AMENDMENT OF SOLICITATION/MODIFICATION OF CONTRACT			1. Contract Number	Page of Pages
2. Amendment/Modification Number DCAM-2007-B-0056-001	3. Effective Date 4/24/2007	4. Requisition/Purchase Request No.	5. Solicitation Caption IFB for Renovation of Lincoln Theatre

14. Description of amendment/modification (Organized by UCF Section headings, including solicitation/contract subject matter where feasible.) The subject solicitation is hereby amended as follows: 1. Attachment A to this amendment provides responses to questions received from bidders. 2. Delete Drawing A-2 - Section on new floor finishes to the existing basement and first floor dressing rooms. Insert Attachment B.				
Except as provided herein, all terms and conditions of the document referenced in Item (9A or 10A) remain unchanged and in full force and effect				
15A. Name and Title of Signer (Type or print)		16A. Name of Contracting Officer Diane Wooden		
15B. Name of Contractor	15C. Date Signed	16B. District of Columbia	16C. Date Signed	
(Signature of person authorized to sign)			4/25/07	
		(Signature of Contracting Officer)

RENOVATIONS AT LINCOLN THEATRE
1215 U STREET, NW

Renovation of Lincoln Theatre –DCAM-2007-B

BASEMENT & 1ST FLOOR PLANS

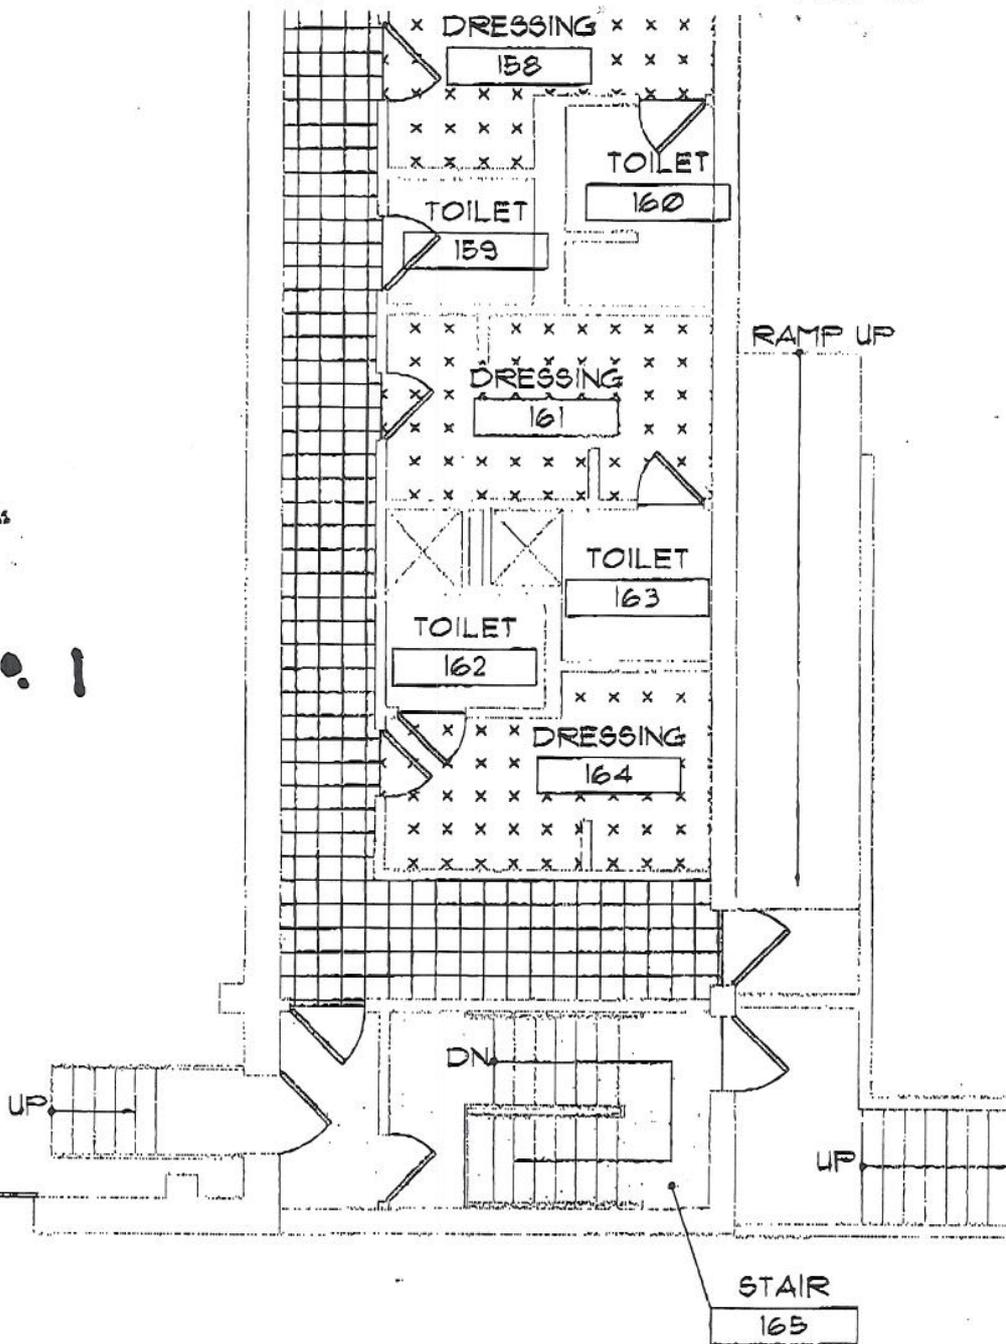
The contract documents clearly indicates areas to be painted. All architectural work in the basement and first floor dressing rooms shall be excluded from this contract. (See Attachment B)
